# Access Compliance Report

### (Curb Ramps)

Intersection ID: 15763	Main Street: MONROE_RD	Cross Street: N_WENDOVER_RD	Location: N
ADA ID: D27F75231CFA	Ramp Type: Perp	Initial Pass/Fail: Fail	Overall Compliance: No
			Severity Score: 21.25

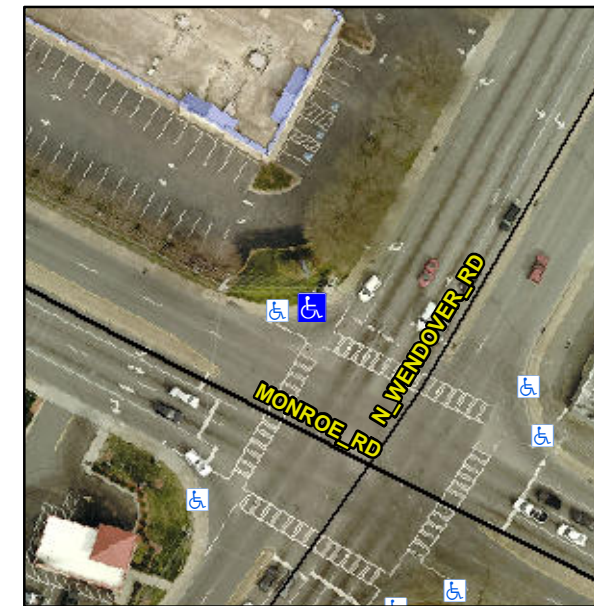
**Not Found, R304.5.1, R304.2.2**

Compliance	Description	Data	Compliance	Description	Data
N/A	Ramp Length (in)	59.0	No	Ramp Slope (%)	9.9
No	Ramp Width (in)	44.0	Yes	Ramp XSlope (%)	0.2
N/A	Flare Type LT	N/A	N/A	Flare Type RT	N/A
N/A	Flare Slope LT (%)	N/A	N/A	Flare Slope RT (%)	N/A
N/A	Flare Traversable LT?	N/A	N/A	Flare Traversable RT?	N/A
N/A	Landing Length (in)	N/A	N/A	DWS Provided?	N/A
N/A	Landing Width (in)	N/A	N/A	DWS Contrast?	N/A
N/A	Landing Slope (%)	N/A	N/A	DWS Length (in)	N/A
N/A	Landing X Slope (%)	N/A	N/A	DWS Full Width?	N/A
N/A	Landing Curb? (Y/N)	N/A	N/A	DWS Offset (in)	N/A
N/A	Shared Landing?	N/A			
N/A	Gutter Ponding?	N/A	N/A	Gutter Slope (%)	N/A
N/A	Gutter Lip Ht (in)	N/A	N/A	Gutter X Slope (%)	N/A
N/A	Painted X Walk1?	Yes	N/A	Painted X Walk2?	N/A
	X Walk 1 Direction	To SE		X Walk 2 Direction	N/A
N/A	X Walk 1 Width (in)	107.0	N/A	X Walk 2 Width (in)	N/A
	X Walk 1 Slope (%)	0.6		X Walk 2 Slope (%)	N/A
	X Walk 1 X Slope (%)	1.4		X Walk 2 X Slope (%)	N/A

**Remove & Replace Entire Ramp.**
